Microcontroller Technical Information

IE-789488-NS-EM1 Emulation Board for Microcontrollers μ PD78947x, μ PD78948x Usage Restrictions		Document No.	ZBG-CD-06-0093	1/1
		Date issued	October 31, 2006	
		Issued by	Development Tool Group Multipurpose Microcomputer Systems Division 4th Systems Operations Unit NEC Electronics Corporation	
Related documents	IE-789488-NS-EM1 User's Manual: U16492EJ1V0UM00	Notification classification	√	Usage restriction
				Upgrade
				Document modification
				Other notification

Notes on Using IE-789488-NS-EM1

Figure 3-1. Position of Emulation Board Fixing Stays (Metal Fittings)

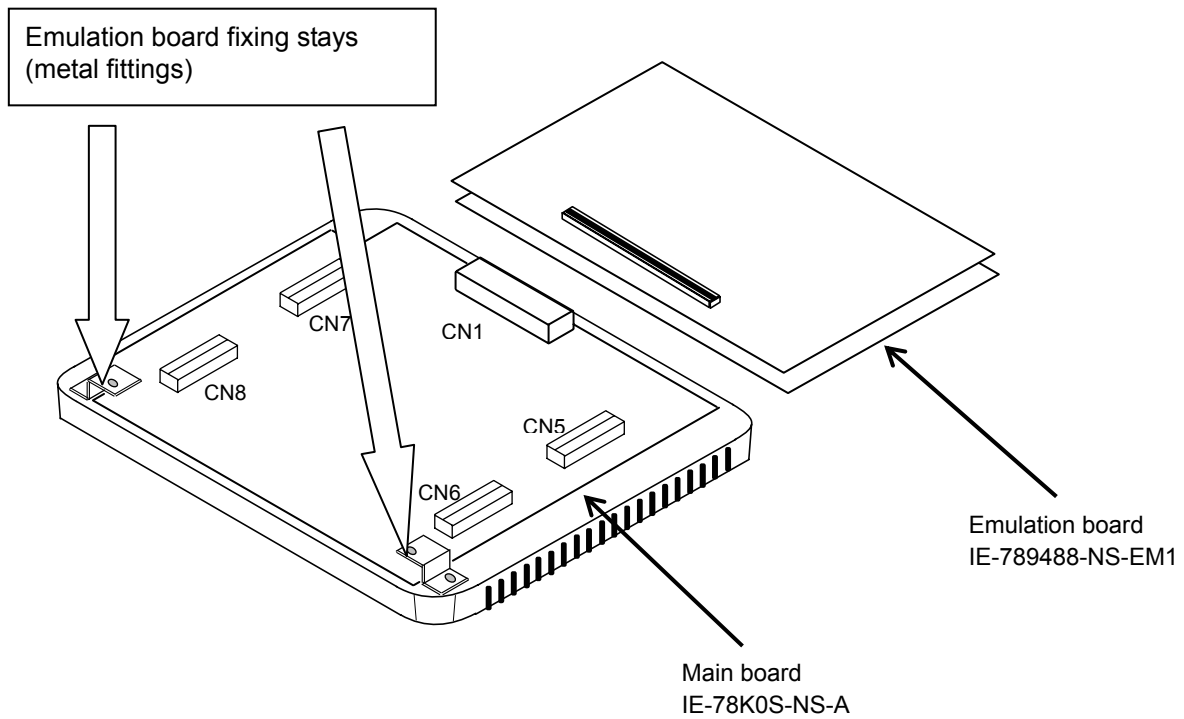
No. 3 Contact bug between IE-78K0S-NS-A emulation board fixing stays (metal fittings) and test pins of the I/O board

When connecting the IE-789488-NS-EM1 to the IE-78K0S-NS-A control code A or B, test pins of the I/O board (CP8 and CP38) contact the IE-78K0S-NS-A emulation board fixing stays (metal fittings).

This bug has been corrected in control code C and later. In addition, the metal fittings have been replaced with the plastic brackets.

If you have not yet upgraded to the IE-789488-NS-EM1 control code C or IE-78K0S-NS-A control code D, remove the fixing stays. Figure 3-1 illustrates the position of the fixing stays.
